Moorebank Precinct East – Stage 2 Modification 4

State Significant Development Modification Assessment

(SSD 7628 MOD 4)

January 2021

Figure 3 | Area 1 Landscape Masterplan

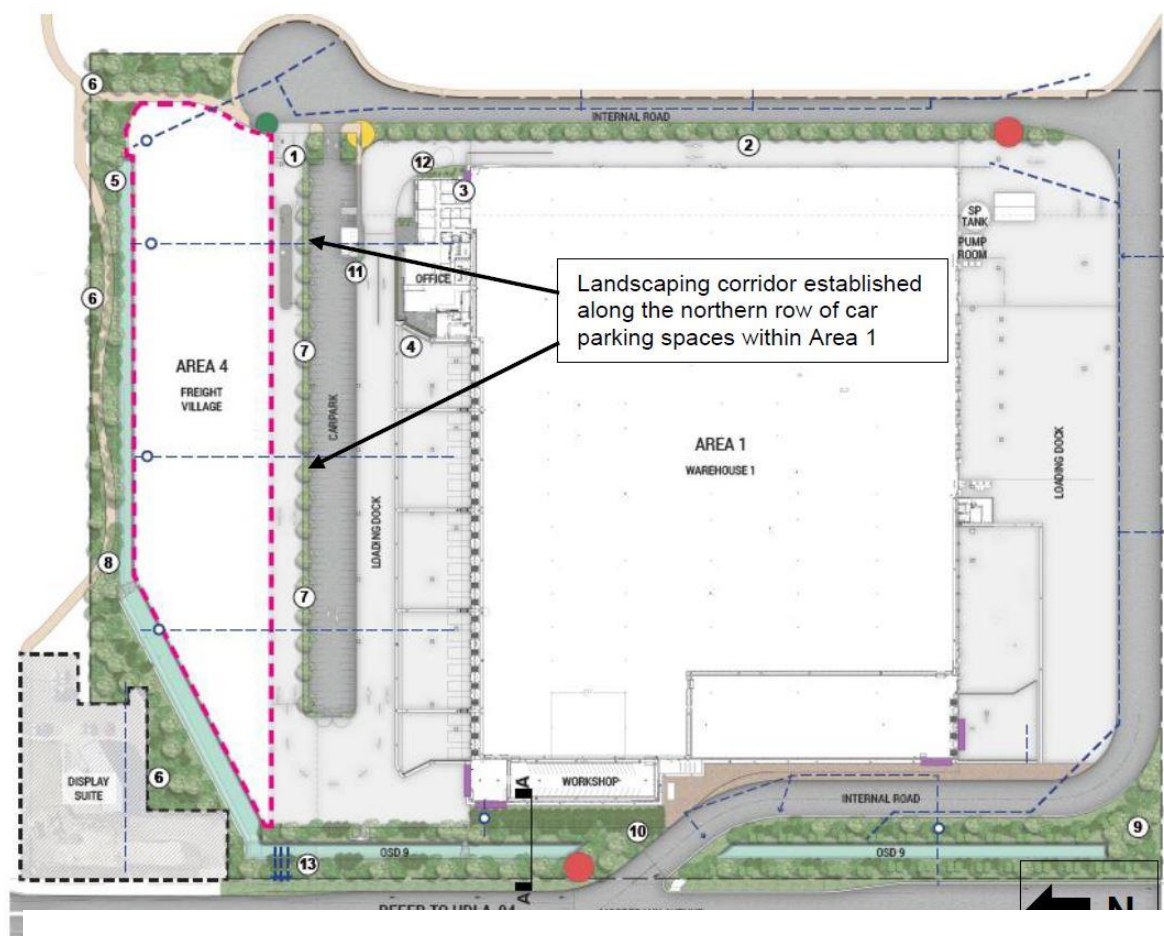
Currently, the “Area 1” car park does not follow the prescription contained within condition B140(e)(vi), which requires car parks on the site to provide a landscaped 2.5 m wide bay every 6 to 8 car spaces, including canopy trees for shade. Instead, the “Area 1” car park involves:

- a landscaping corridor of approximately 1.5 m wide by 186 m in length, adjacent to the northern boundary of the Area 1 car parking area
- a typical tree spacing of every 9-10 m for canopy tree planting (generally every 4 car spaces)
- no trees planted adjacent to the southern row of parking.

The Department notes approval was issued for the Urban Design and Landscape Plan (UDLP) for Area 1 (Warehouse 1) of MPE on 5 June 2020 under condition B140, however, excluding condition B140(e)(vi) due to this non-compliance.

As the Planning Secretary does not have the authority to approve an Urban Design and Landscape Plan, which does not comply with condition B140(e)(vi), the Applicant notes they seek to modify the wording of the Condition of Consent to allow for the current car parking and landscaping within Area 1 to be permissible under an exception to the condition. This will enable the Planning Secretary to consider approval of the UDLP provisions in its current form.

Figure 4 | Area 1 landscaping anticipated shading 5 years after installation

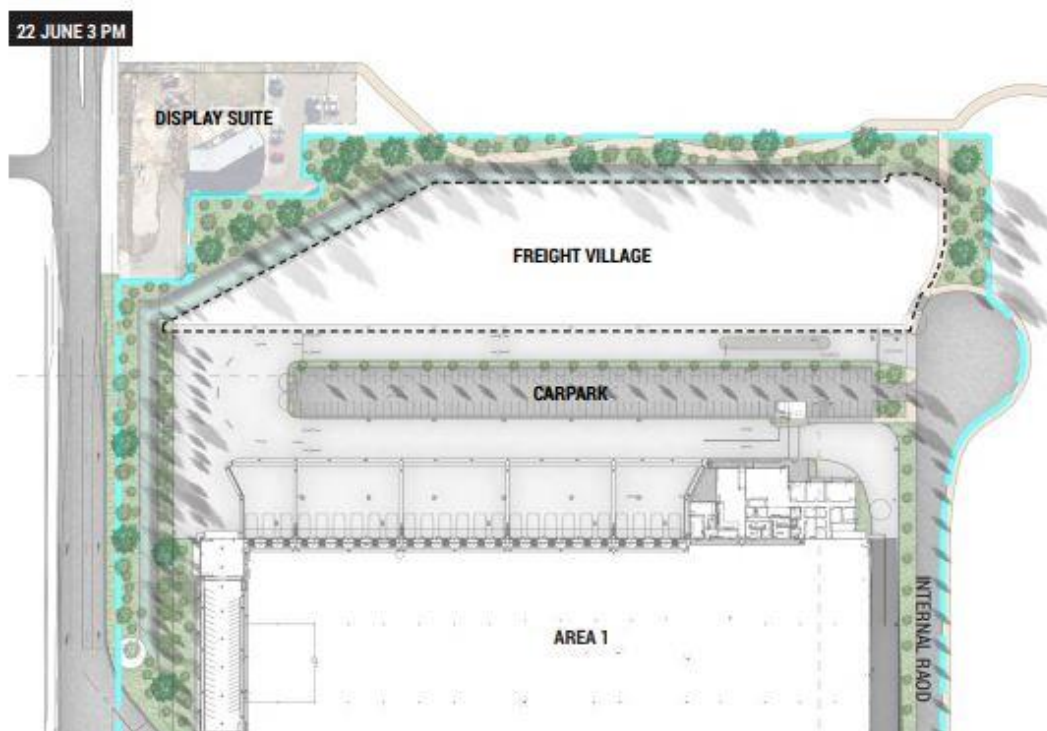
The Applicant asserts that the current non-compliant landscaping on the Area 1 carpark provides an enhanced landscaping outcome from what could be achieved under strict compliance with condition B140(e)(iv). The Applicant considers that additional mature trees provided as part of the alternative landscaping achieves a greater amount of canopy shade, increasing shading for cars and the carpark. Further, the site orientation and sun patterns under the current carparking scheme will result in, over the long term, anticipated shade from mature canopy trees to generally extend across the full width of the car parking area. Given the north to south orientation of the Area 1 carpark and resulting sun patterns, the Department considers that the proposed alternative landscaping scheme, over the longer term, would provide an acceptable amount of shading within the southern bays on the southern row of the car parking, enhancing the amenity experienced within the car park.

Figures 4 and 5 below illustrate the Applicant's predicted shading to be achieved under the proposed alternative landscaping after 5 and 15 years of installation.

As such, the Department is satisfied that the proposed alternative landscaping scheme would achieve the broader objectives of the condition.
